C. AMENDMENTS TO THE DRAWING FIGURES

D. REMARKS

This Amendment is in response to a non-final Office Action bearing a mailing date of July 13, 2007.

The Applicant's claimed invention is to a surface-mounted anchoring system for use in the construction of a wall. The wall more specifically is a cavity wall having an inner wythe or, more commonly, a backup wall and an outer wythe or, more commonly, a veneer. In the cavity between the wythes, it is required by some building codes to provide insulation on the exterior of the inner wythe, the integrity of which is to be intact after the anchoring system is installed. All of this information is preamble.

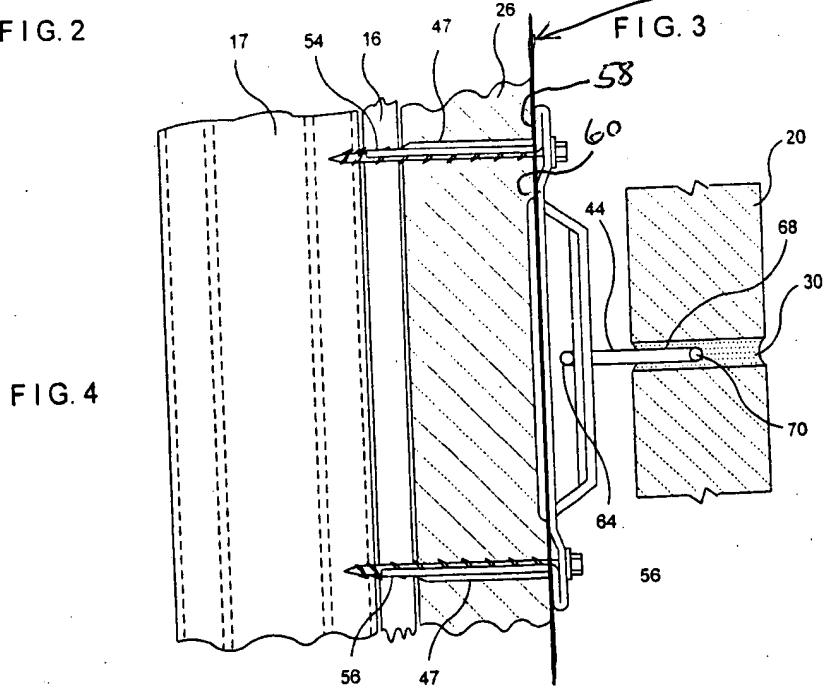
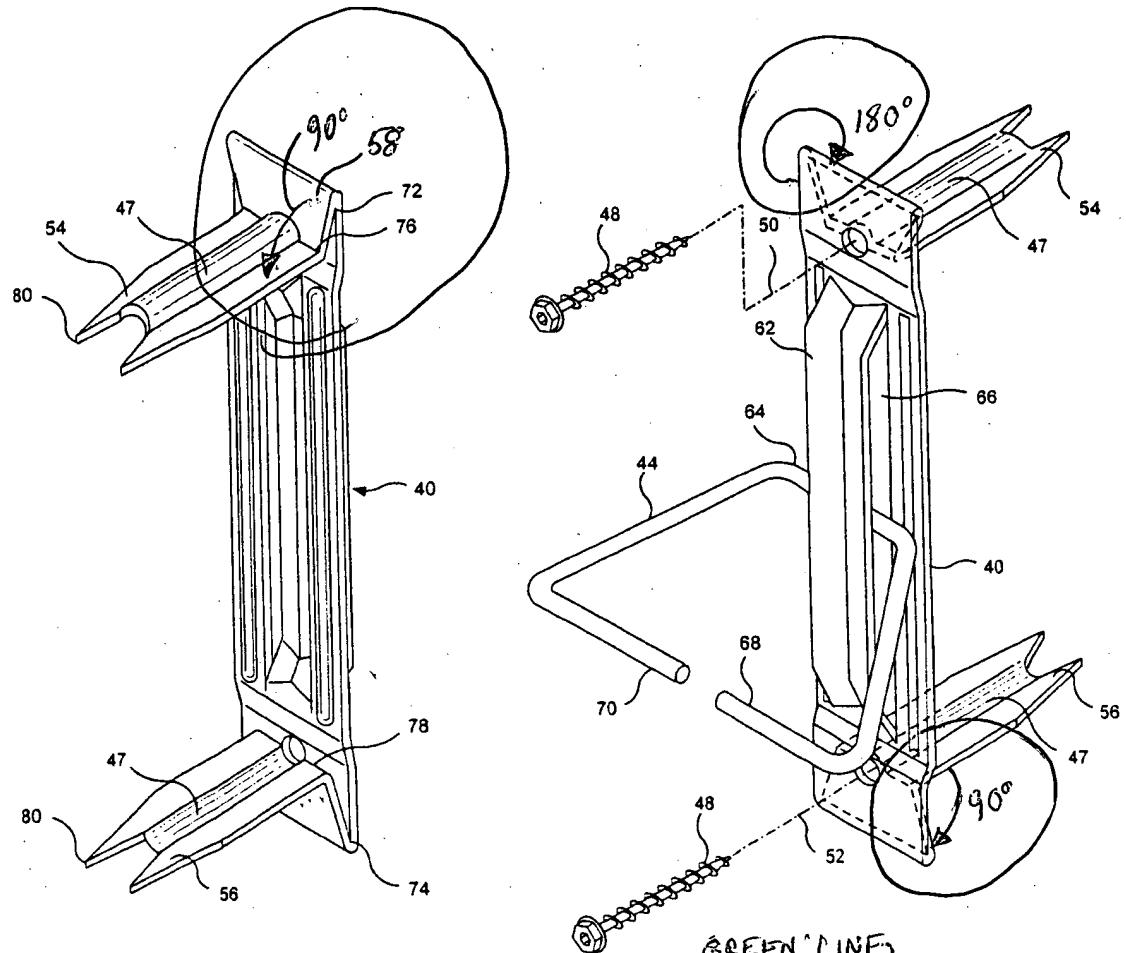
The Examiner errs in Paragraph 3 of the Detailed Action in stating that *the two surfaces are not shown as coplanar in the drawings*. In the visual aid provided herewith a green line is drawn showing the coplanar characteristic of the two surfaces.

The Figures 2, 3, and 4 have been reduced for placement on a single page. The text, when read together with the illustrations, clearly show the sheetmetal bending involved in the construction of this wall anchor. As an aid to understanding the text, colored markings on the drawings provide an additional visual aid. The green angular markings show the leg bends and the red angular markings show the base bends. The green line superimposed on Fig. 4 show surface 58 and surface 60 as being coplanar. A typical series of metalworking steps to produce the finished inboard legs 54 and 56 would include stamping of the basic flat shape, swaging the channels 47, folding the 90° bend between the legs 54 and 56 and the leg bases 58, folding the 180° bend between the leg bases 58 and the base surface 60, and swaging the leg bases 58 and base surface 60 into a substantially coplanar form. The Examiner is requested to re-read the text at Paragraph 62 of the Application

in the light of the above discussion and reconsider Claim 13.
